Product / Process Change Notification (PCN)

PCN #: PCN_IndLHMI_20200124

Affected Series: WE-LHMI-4012; 74437321xxx, S12100016, S12100017, S13100073

DETAIL OF CHANGE:

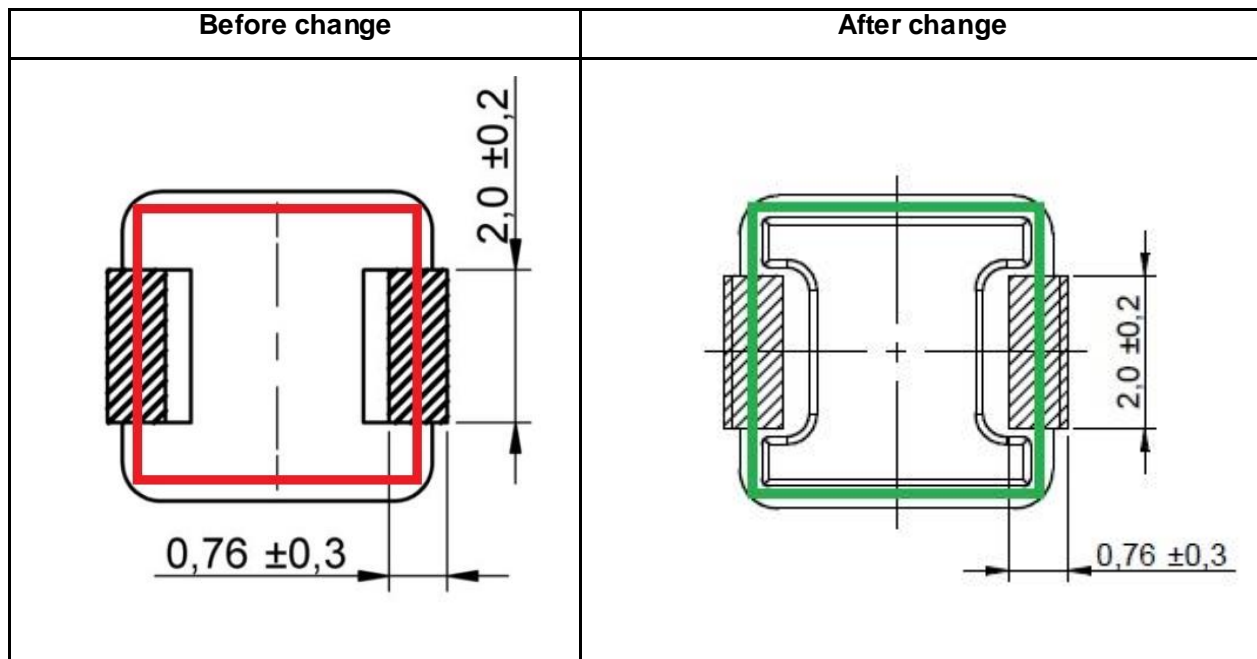
The previous shape of the indentation around the pins will be changed from square to round edges to increase the efficiency of the production process.
